RESIDENTIAL FLAT BUILDING DEVELOPMENT

17 (LOT 1 DP 973520), 19 (LOT 1 DP 972422), 21 (LOT 1 DP 972554) SHIRLEY ROAD, ROSEVILLE NSW 2069

DEVELOPMENT APPLICATION

Schedule of Changes (RFI)		
ITEM NO.	DESCRIPTION	DRAWING REFERENCE
PLANNING AND URBAN DESIGN		
ITEM 1.1	Ground Floor and Level 1 courtyards revised to balconies at building setback, and replaced with deep soil landscaping.	AR 103, AR 104

DRAWING TITLE
Level 1-3 (Typical) GA Plan

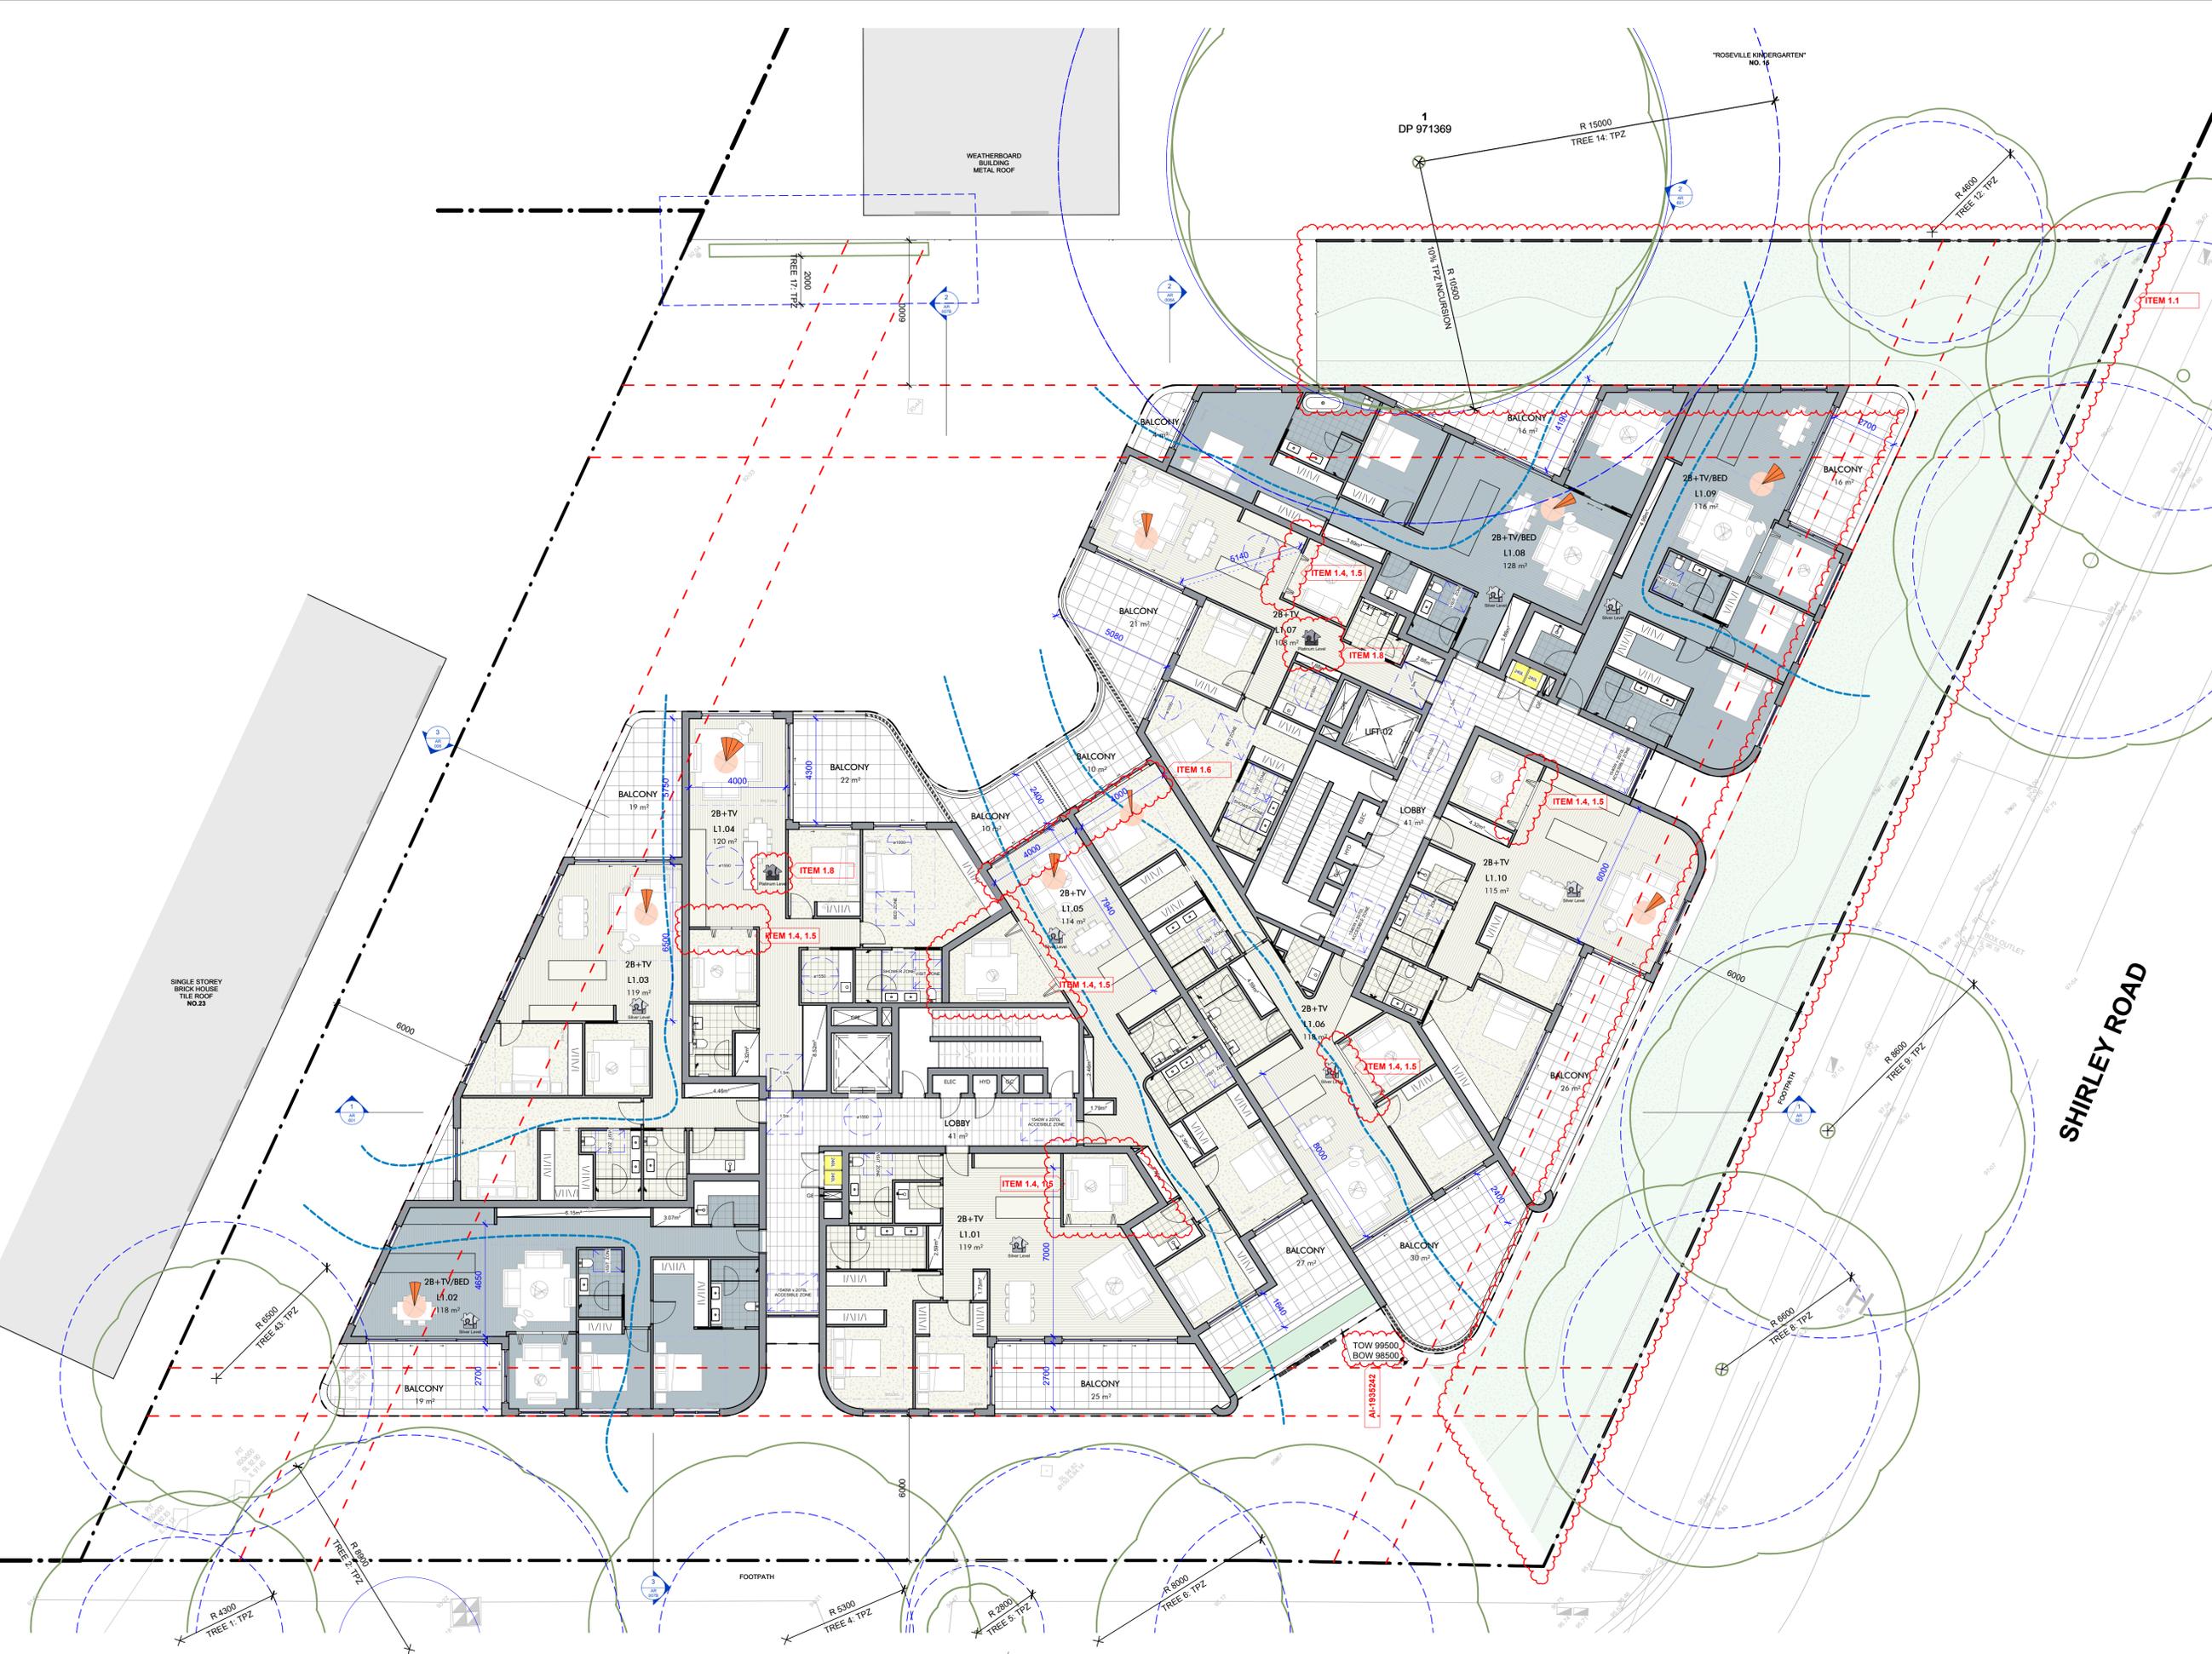
ITEM 1.4, 1.5	Design revised to increase natural daylight and ventilation to TV rooms.	AR 104, AR 105, AR 106
ITEM 1.6	Dimensions added demonstrating 4m internal width per ADG 4D-3.	AR 104, AR 105, AR 106

ITEM 1.7	Affordable Units revised. Total area provided demonstrating at least 2% of GFA will be used for affordable housing.	AR 001, AR 007
ITEM 1.8	Total of nine (9) Platinum Level Livable units and car spaces provided to achieve 15% of total apartments.	AR 001, AR 100, AR 101, AR 102, AR 104, AR 106

ITEM 1.12	Storage walls adjacent to external shoring walls amended to mesh for maintenance.	AR 001, AR 100, AR 101, AR 102, AR 104, AR 106
ITEM 1.13	GFA Plans increased in scale, additional sheet added.	AR 007, AR 007A
LANDSCAPING

DRAWING TITLE
Level 4 GA Plan

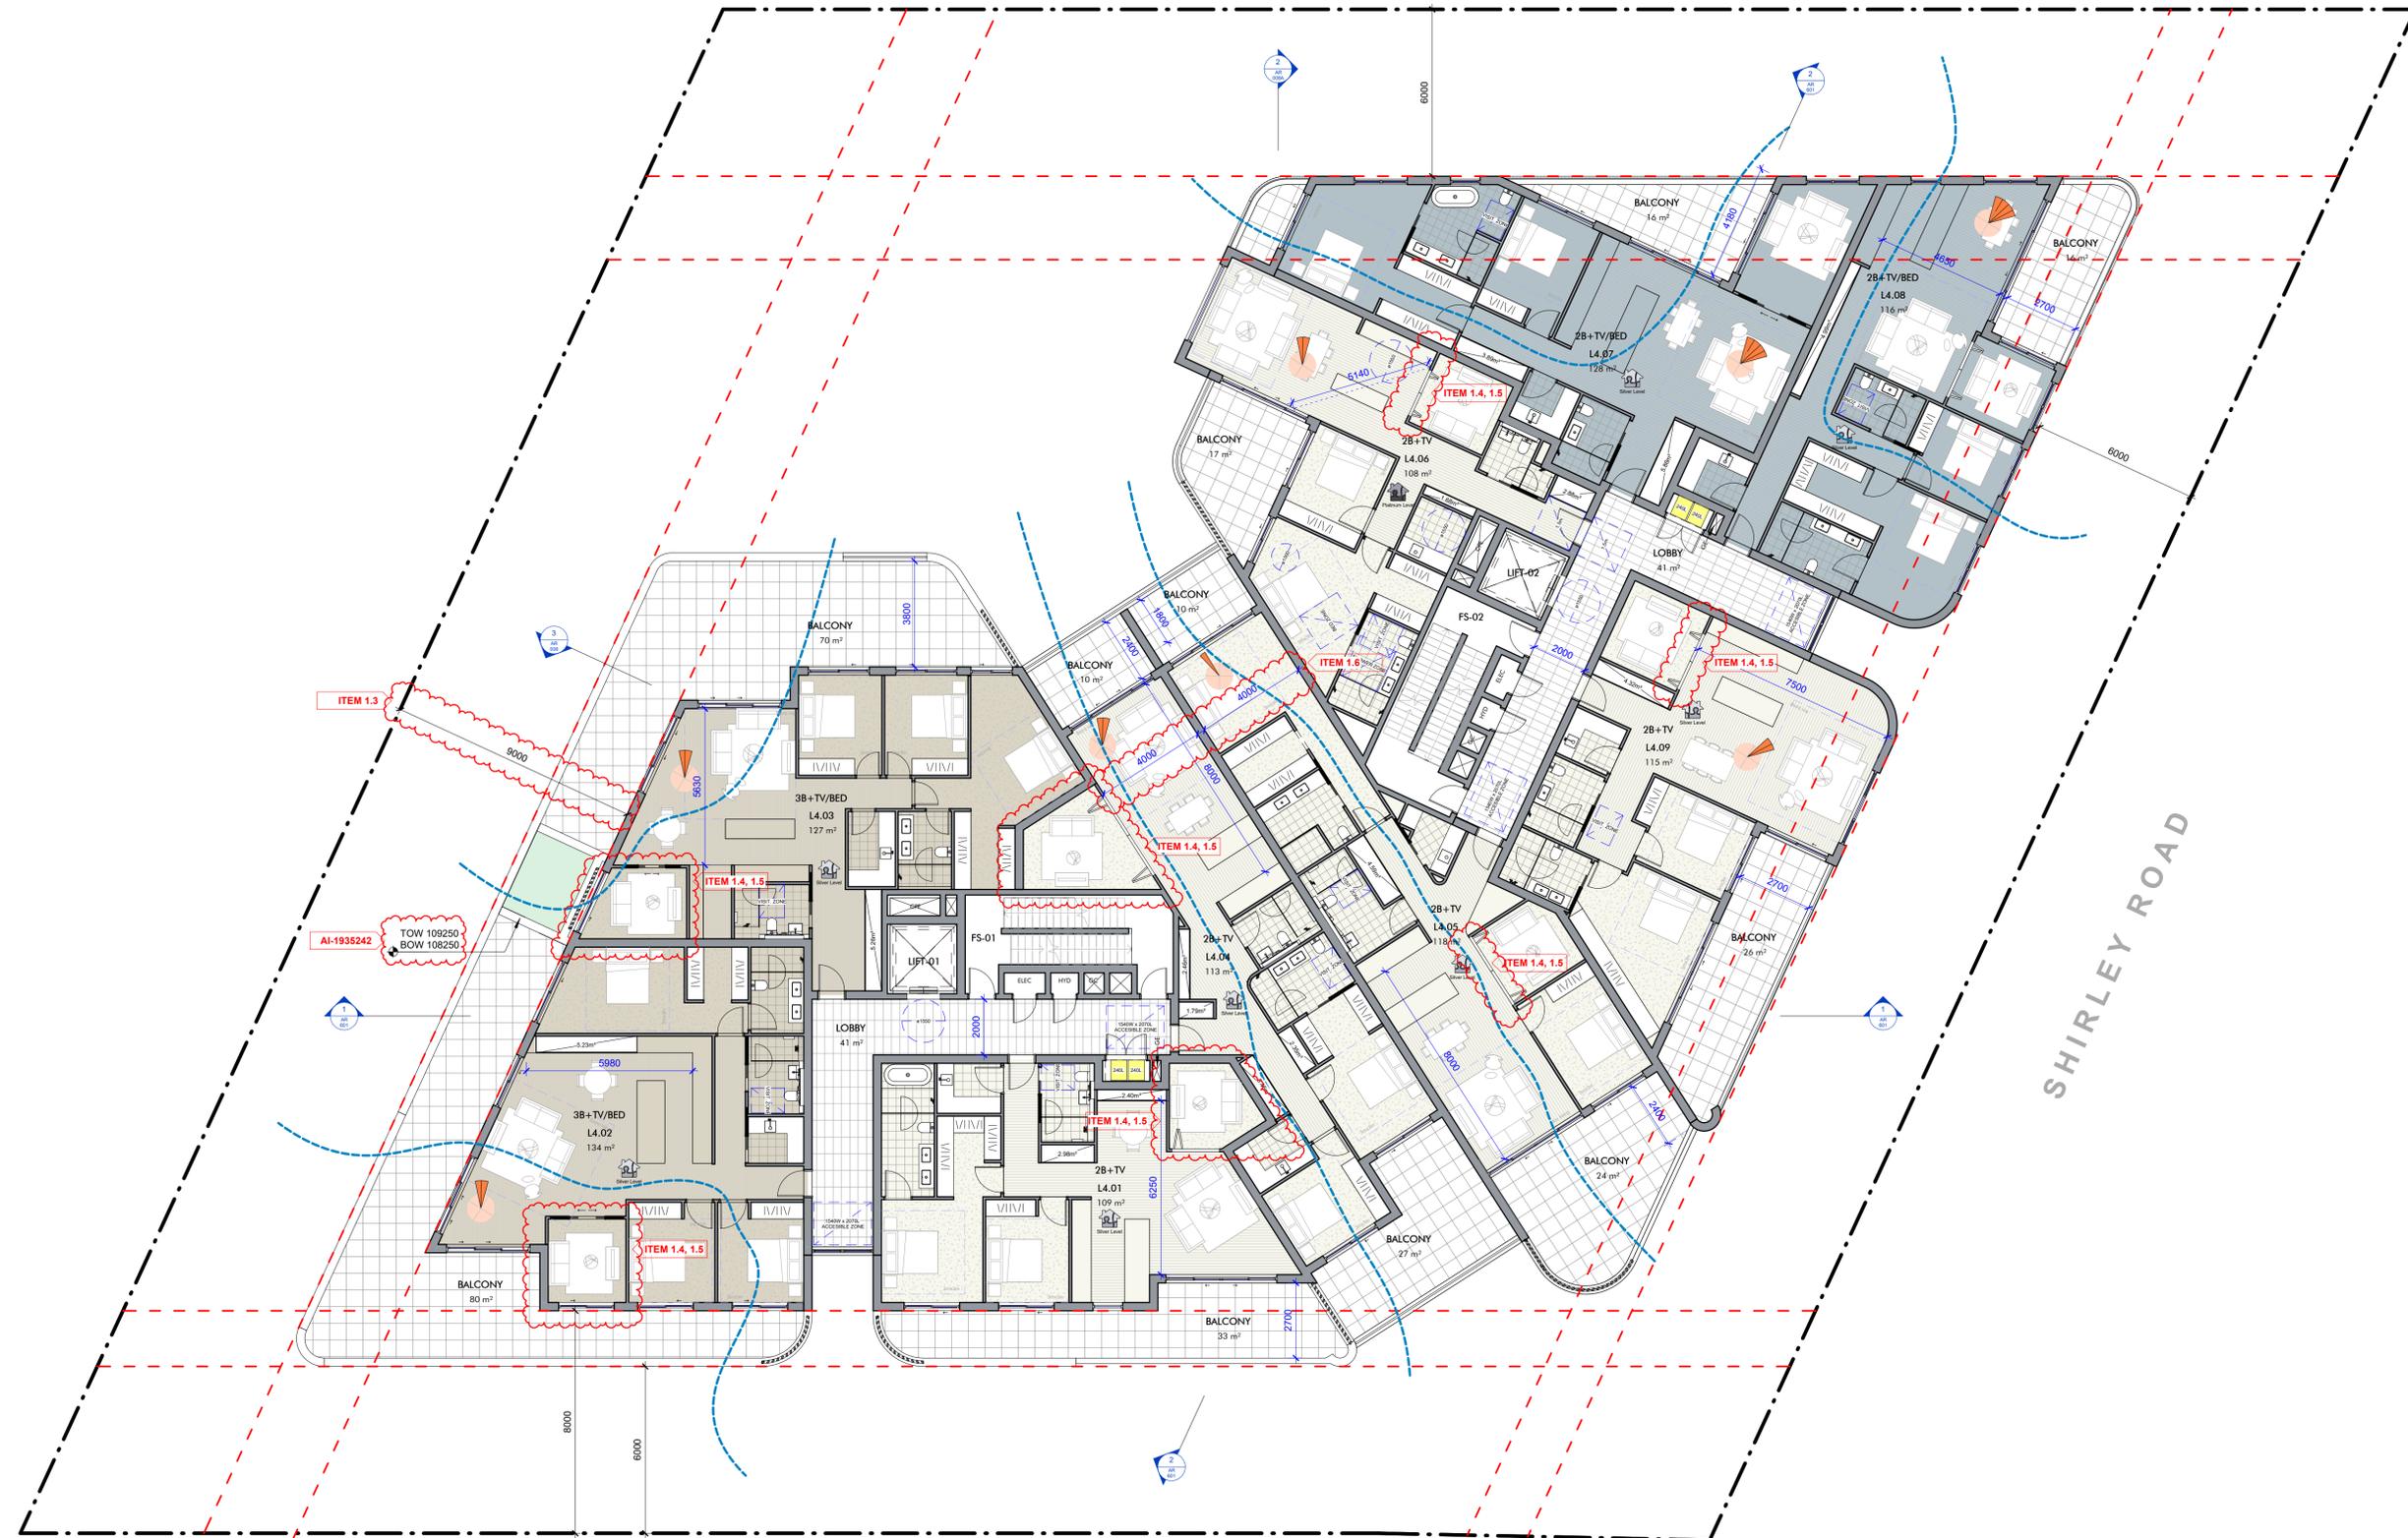
ITEM 1.2	Building levels amended to allow accessible street entry without stairs or platform lifts i.e. 1 in 40 maximum grade.	AR 103
ITEM 1.3	Levels above four storeys amended to maintain 9m setback from the site boundaries.	AR 105, AR 106, AR 107
